CITY OF SURPRISE
Planning and Zoning Commission Agenda
16000 N. Civic Center Plaza
Surprise, AZ 85374

Thursday, April 20, 2017 @ 6:00 PM
 COUNCIL CHAMBERS

Consideration and action on the Site Plan for a Behavioral Health Hospital generally located north of Westgate Drive and west of Dysart Road.

REPORT TO THE PLANNING AND ZONING COMMISSION

1 COLORED OVERALL EXTERIOR ELEVATION - EAST
1/16" = 1'-0"

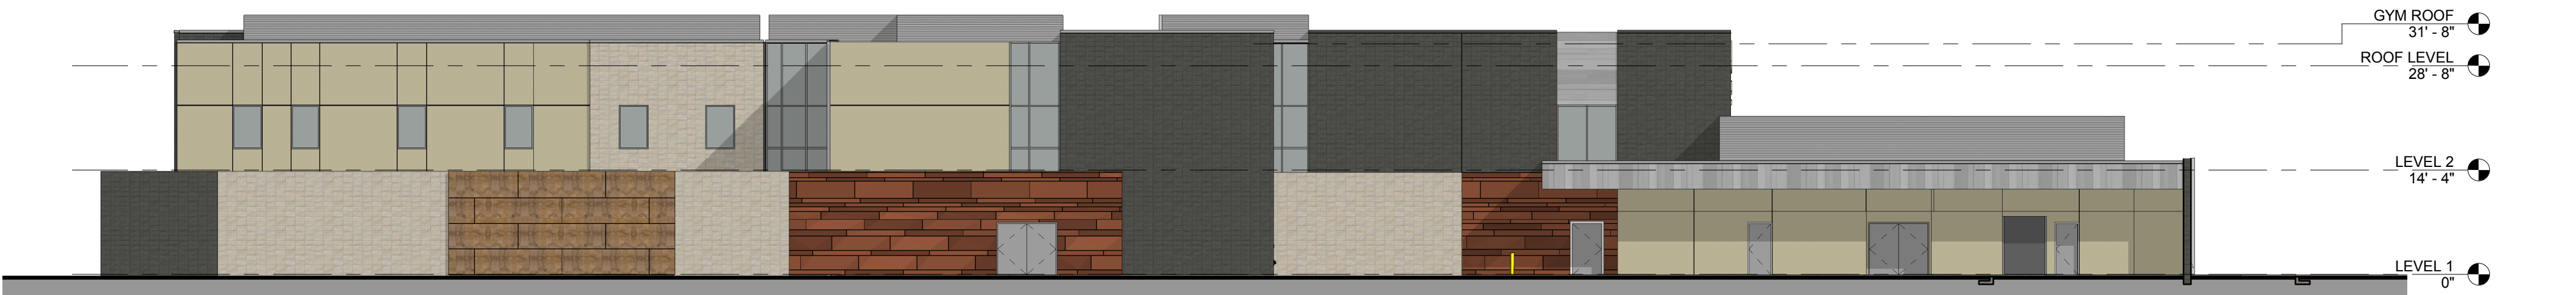
2. Sheet AE203: Partial Exterior Elevations East 1 and South 3 will include the buildings in the background.
